**Independent Hearing
And Assessment
Panel Meeting**

6 June 2016 – 6.00pm

CENTRAL WARD**1 349-351 BEAMISH STREET, CAMPSIE: DEMOLITION,
CONSTRUCTION OF SIX STOREY MIXED USE DEVELOPMENT
WITH RESIDENTIAL UNITS ABOVE RETAIL/COMMERCIAL
GROUND FLOOR AND TWO LEVEL BASEMENT PARKING**

D/A No:	DA-343/2015
Applicant:	CD Architects
Owner:	Gee N Gee Pty Ltd
Zoning:	B2 Local Centre under Canterbury Local Environmental Plan 2012
Application Date:	7 August 2015, amended plans received by Council on 24 February 2016

Variation from 18m height standard along elevation

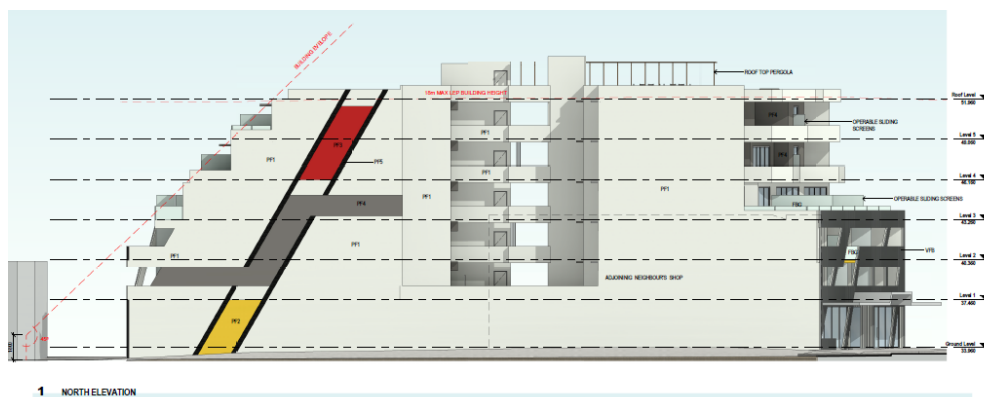
The extent of which the proposal exceeds the maximum building height of 18m is shown in the diagram below and is over a portion of the proposal comprising part of the uppermost residential level, the lift and stairwell over-run, structures associated with the communal open space on the rooftop level, and, a small proportion of the roof structure. The extent of variation is 3.2m which equates to 17% of the control.

It is considered that an appropriate degree of flexibility in applying the Height of Building standard is warranted in this instance as the proposed development is consistent with the desired outcome for the site and will provide a building that exhibits good articulation and will improve the streetscape presentation and building form for the location.
